UNITED STATES PATENT AND TRADEMARK OFFICE

APPLICATION NO.	FILING DATE	FIRST NAMED INVENTOR	ATTORNEY DOCKET NO.	CONFIRMATION NO.
10/713,245	11/14/2003	Robert E. Oidtman	3115	1192

Office Action Summary	Application No.	Applicant(s)	
	10/713,245	OIDTMAN, ROBERT E.	
	Examiner	Art Unit	
	Noah C. Hawk	3637

DETAILED ACTION

Aberle, Figure 9

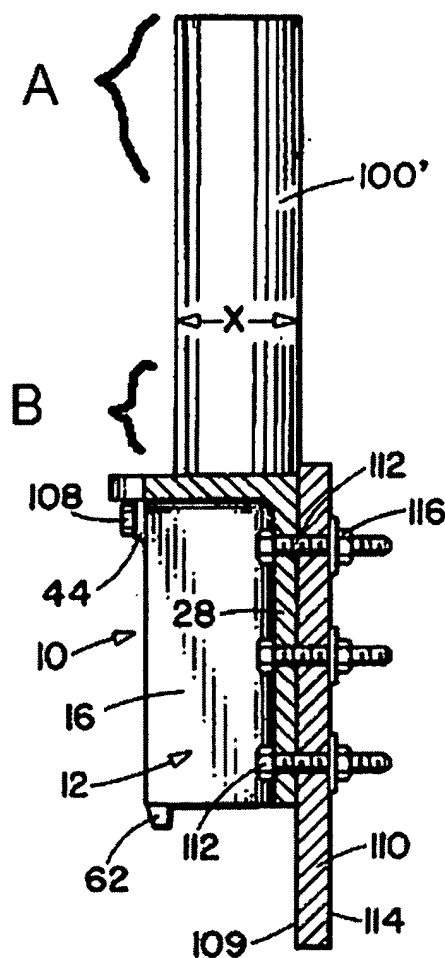
8. Claims 1-3, 11, 12 and 14 are rejected under 35 U.S.C. 102(b) as anticipated by or, in the alternative, under 35 U.S.C. 103(a) as obvious over Aberle in US Patent 5618078. Aberle discloses a bracket and pole assembly comprising a bracket (10)

comprising a bracket shaft (20) enclosed by three bracket walls (14,16,18) such that an end of a first bracket wall (16) is attached to a second bracket wall (14) and an end of the second bracket wall is attached to an end of the third bracket wall (18), two bracket shaft joist walls (28,30) separated by the bracket shaft (20), the first bracket shaft joist wall (28) being substantially perpendicularly connected to the end of the first bracket wall (16), the second bracket wall (14) being substantially perpendicularly connected at an end to a first end of the third bracket wall (18), the second bracket shaft joist wall (30) being substantially perpendicularly connected to the second end of the third bracket wall (18), and a bottom support (48) in the form of a base plate, the bracket being attachable to a floor joist to a raised flooring surface directly below a hole in a raised flooring surface, and a pole assembly comprising a removable hollow pole (100), an end portion of the pole being removably insertable in the bracket and supportable on the bottom support. Aberle is silent on whether the pole (100) is hollow, however, hollow poles are well known in the art and it would have been obvious to one of ordinary skill in the art at the time of invention to use a hollow pole in order to provide a lighter weight pole. Further, Aberle discloses a filler plug with a bottom section (B) generally cylindrical in shape (see Aberle, Column 4, lines 46-48) and a generally circular top section (A).

Wright, Sr. Figure 1

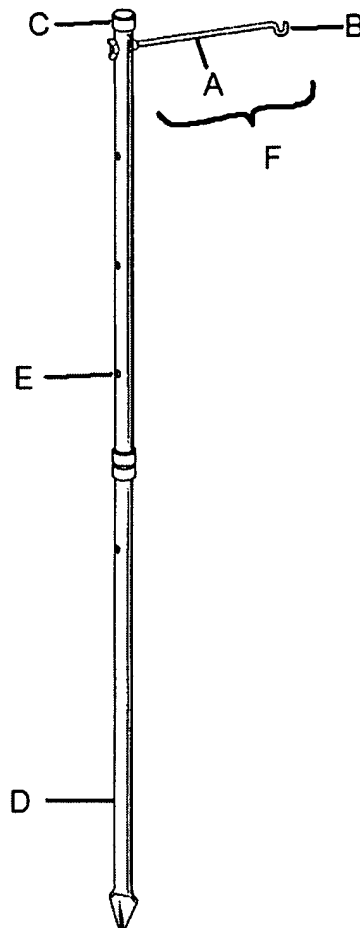
9. Claims 4 and 6 are rejected under 35 U.S.C. 103(a) as being unpatentable over Aberle as applied to claim 1 above, and further in view of Wright, Sr. in US Patent D462889. As stated above, Aberle teaches the limitations of Claim 1 including a pole assembly. Aberle does not disclose a plurality of cushion strips, a cap plug, or a hook mechanism. Wright, Sr. discloses a pole with a cap plug (C) and a hook mechanism (F) comprising a linear portion (A) extending through a hook bolt shaft (best seen in Wright,

Sr., Figure 1) and a curved portion (B). The Office takes official notice that it is well known to use cushioning means, such as cushion strips longitudinally oriented along a pole, to insure a tight fit when two objects are insertably related. It would have been obvious to one of ordinary skill in the art at the time of invention to modify the device of Aberle by adding cushion strips, and a cap plug and hook mechanism as taught by Wright, Sr. on the pole assembly in order to insure a tight fit between the pole and the bracket, to prevent water from getting in the top of the pole and in order to add utility to the pole.

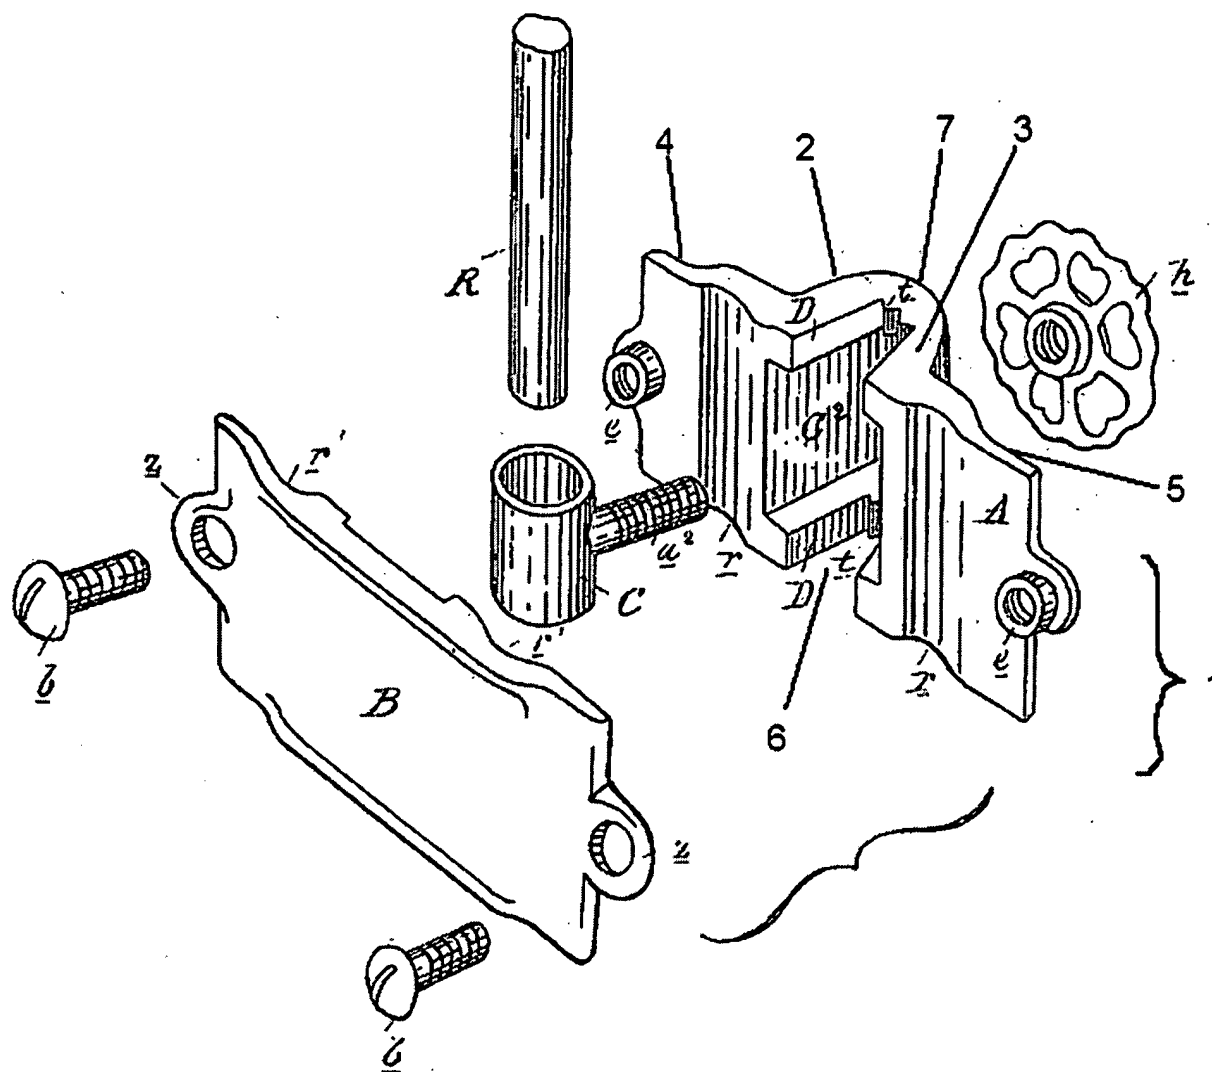
10. Claim 5 is rejected under 35 U.S.C. 103(a) as being unpatentable over Aberle in view of Wright, Sr. as applied to claim 4 above, and further in view of Tennant in US Patent 4662132. Aberle in view of Wright, Sr. discloses a table attachment bolt shaft (E) extending transversely through the pole below the hook mechanism but does not disclose a base plug. Tennant disclosed a base plug (74) removably insertable in a bottom end of a pole (22). It would have been obvious to one of ordinary skill in the art

to modify the device of Aberle in view of Wright, Sr. by adding a base plug onto the pole in order to prevent insects from crawling into the pole from the bottom opening.

Ericksen, Figure 3

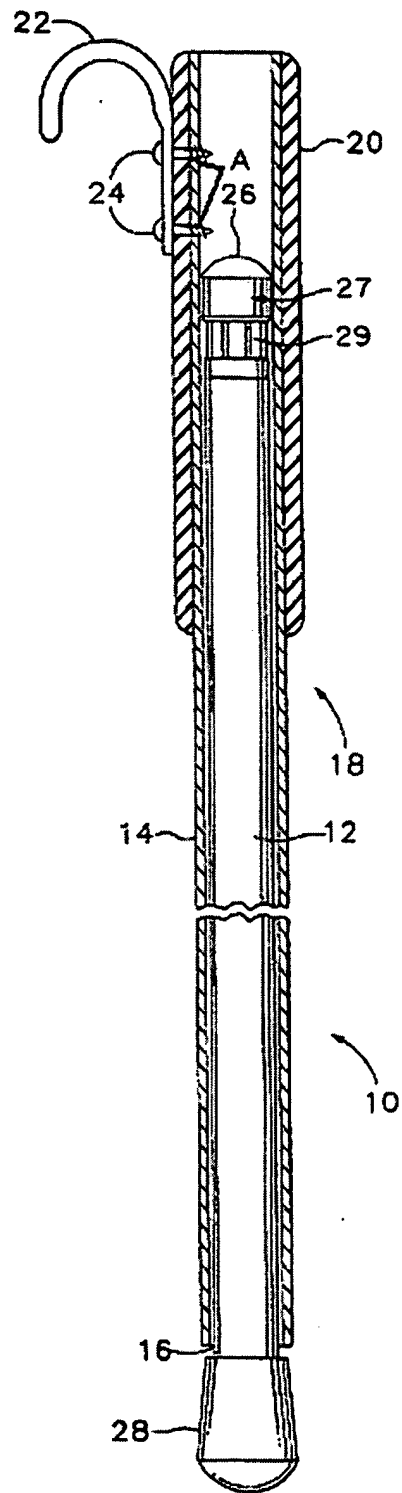
13. Claim 13 is rejected under 35 U.S.C. 103(a) as being unpatentable over Aberle as applied to claim 12 above, and further in view of Ericksen in US Patent 5628538. As stated above, Aberle teaches the limitations of Claim 12 including a bracket and pole but fails to teach a hook mechanism. Ericksen teaches a hook mechanism with a hook (22), a plurality of hook bolt shafts (A) extending transversely through the pole (14) and hook bolts (24) insertable through the hook and hook bolt shafts. It would have been

obvious to one of ordinary skill in the art at the time of invention to modify the device of Aberle by adding a hook mechanism in order to allow the user to hang articles from the pole.

Lee, Figure 7

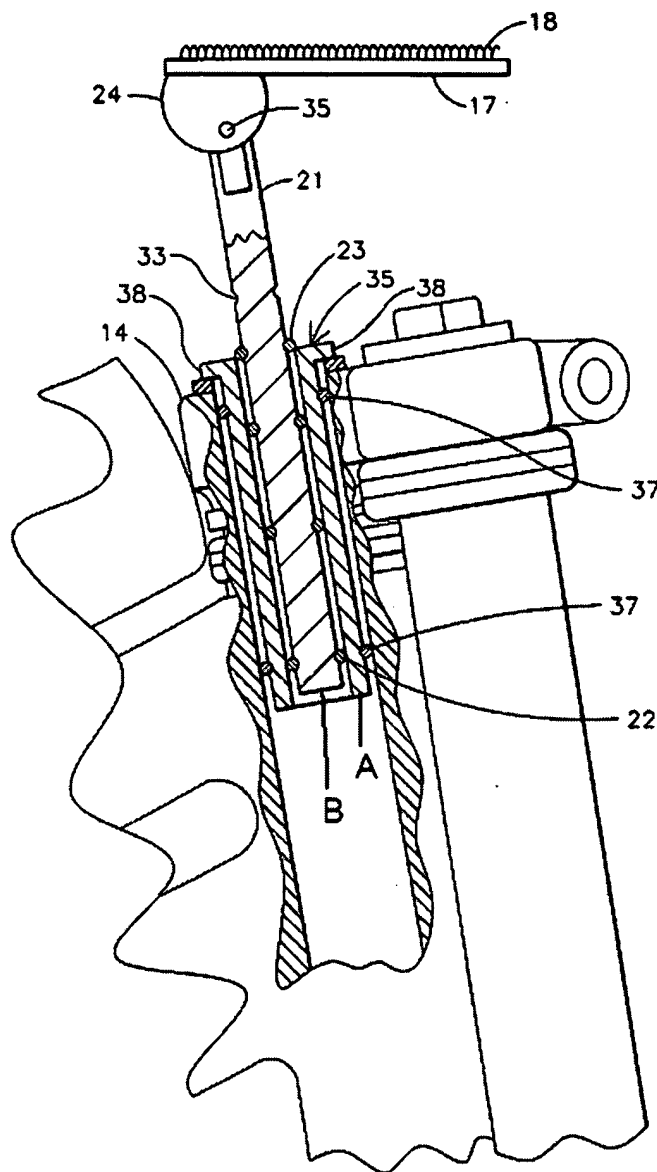
14. Claim 15 is rejected under 35 U.S.C. 103(a) as being unpatentable over Aberle as applied to claim 3 above, and further in view of Lee in US Patent 6378815. As stated above, Aberle teaches the limitations of Claim 3 including a pole assembly. Aberle does not disclose a step down plug. Lee discloses a step down plug (35, best seen in Lee, Figure 7), which comprises a step down plug top section (38), a step down plug bottom section (A) connected to the step down plug top section and removably inserted in a shaft, and a generally circular step down plug aperture (B) extending through a center of the step down plug top section and the step down plug bottom section. It would have been obvious to one of ordinary skill in the art at the time of invention to modify the device of Aberle by using a step down plug as taught by Lee in order to provide means to mount poles of smaller diameter than the bracket shaft in the bracket.

Fetter, Figure 5

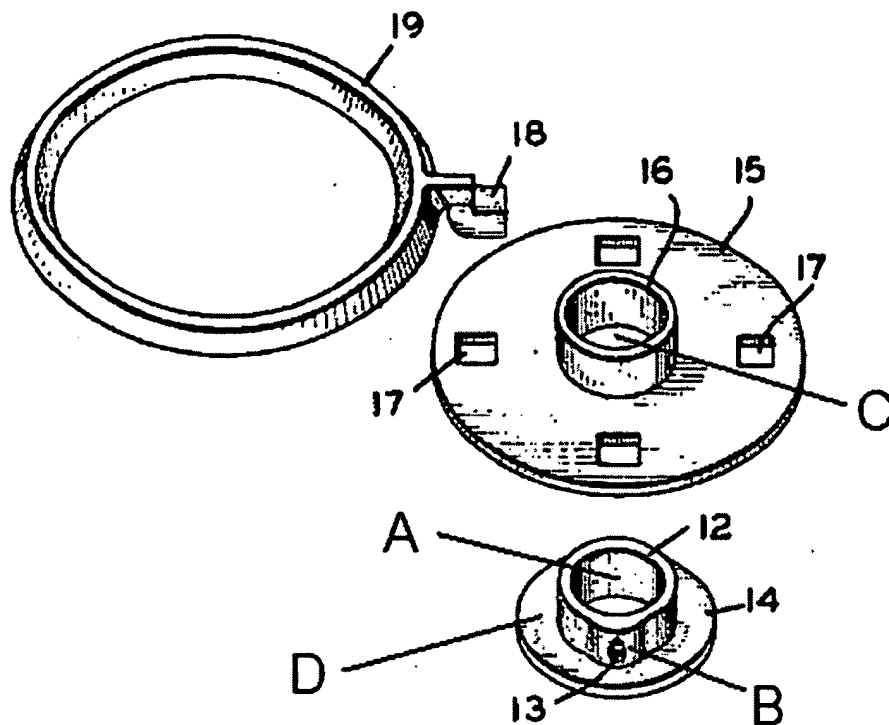
15. Claims 16-18 are rejected under 35 U.S.C. 103(a) as being unpatentable over Aberle as applied to claim 3 above, and further in view of Fetter in US Patent 2970701. As stated above, Aberle teaches the limitations of Claim 3 including a pole assembly. Aberle does not disclose a table attachment mechanism. Fetter discloses a table

attachment mechanism comprising a table attachment top section (14) and a table attachment bottom section (12) connected to the table attachment top section such that both are generally cylindrical in shape and a diameter of the table attachment bottom section is smaller than a diameter of the table attachment top section (relative sizes best seen in Fetter, Figure 3), a generally circular table attachment aperture (A) extending through the center of the table attachment top section and the center of the table attachment bottom section with a diameter about equal to an outer diameter of a pole (11), and a table bolt shaft (B) extending transversely through the table attachment bottom section. Fetter discloses that the table attachment aperture (A) is slidable over the pole (11) and the table attachment is removably secured to the pole by a table bolt (13) inserted through the table bolt shaft (B) (see Fetter, Column 2, lines 18-26). It would have been obvious to one of ordinary skill in the art at the time of invention to modify the device of Aberle by adding a table attachment mechanism therewith as taught by Fetter in order to allow the user to removably attach a table to the pole.
